Accepted Fire Service Installations Proposal
under Previous Application No. A/YL-KTN/837

**Submission for Compliance with Approval Condition (g)
– the Submission of a Fire Service Installations Proposal**

**Proposed Temporary Public Vehicle Park (excluding Container Vehicle) for a
Period of 5 Years in “Comprehensive Development Area (1)” Zone, Lots 1750A9
(Part) and 1905 RP(Part) in D.D. 107, Cheung Chun San Tsuen, Kam Tin, Yuen Long
(Planning Application No. A/YL-KTN/837)**

Appendix I - Response-to-Comment

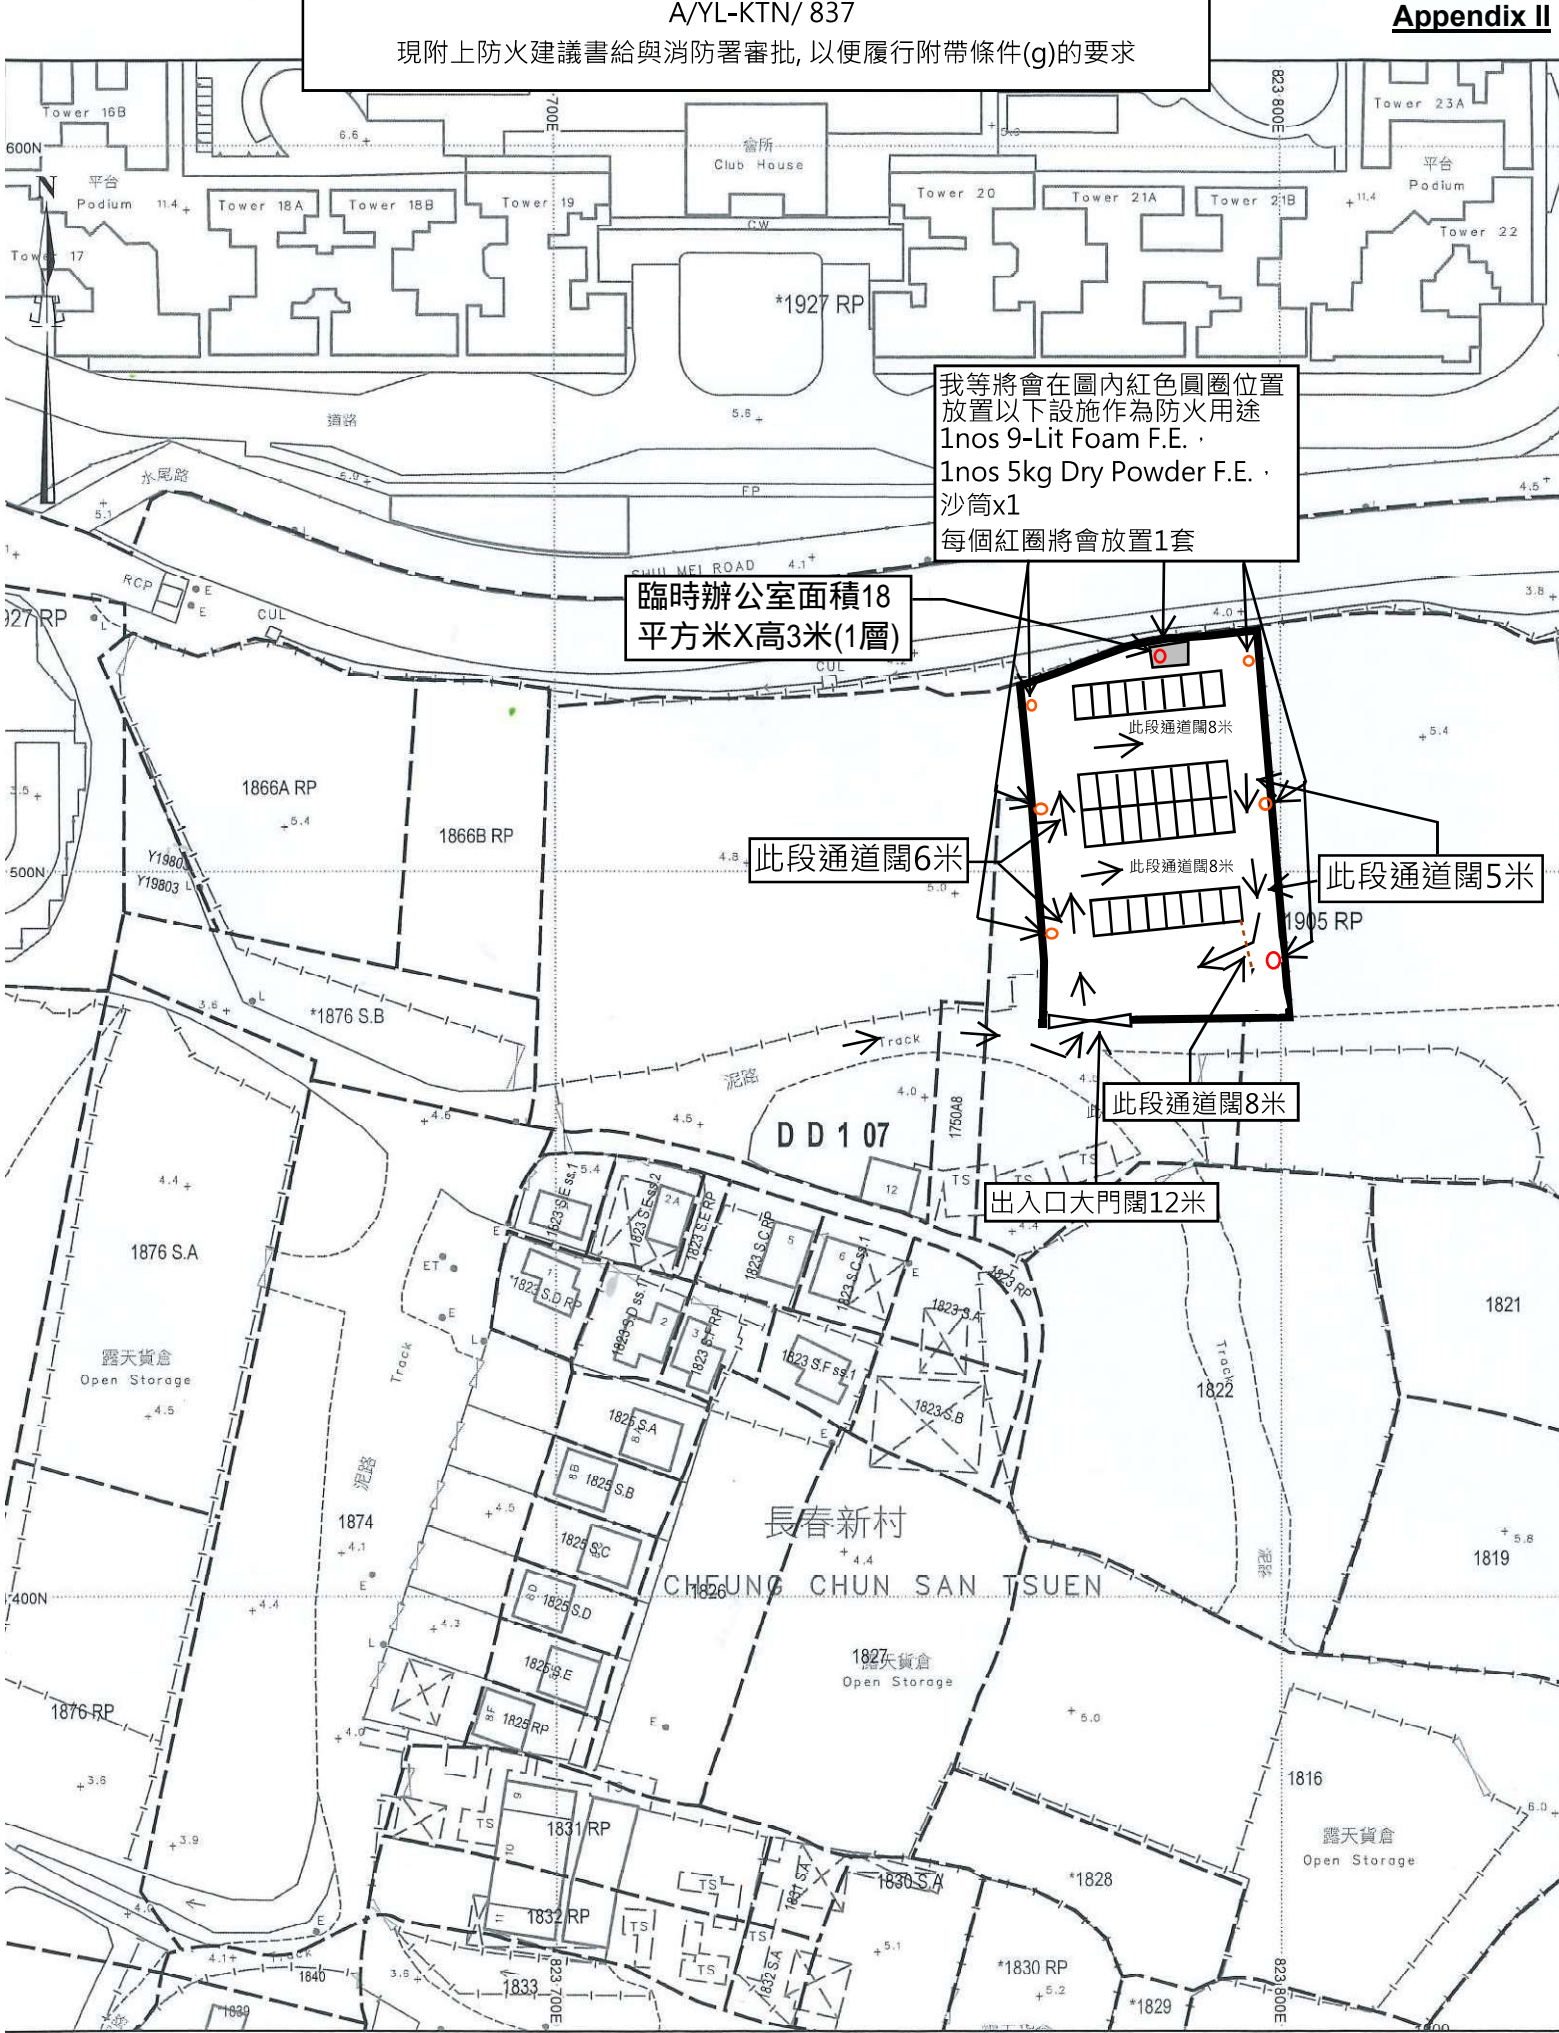
| Departmental Comments | | Applicant's Responses |
|---|--|--|
| (a) | Portable fire extinguisher(s) shall be provided in the office. | Portable fire extinguisher will be provided in the office. Please refer to the revised fire service installations proposal (Appendix II). |

我等將會在圖內紅色圓圈位置
放置以下設施作為防火用途
1nos 9-Lit Foam F.E.
1nos 5kg Dry Powder F.E.
沙筒x1
每個紅圈將會放置1套
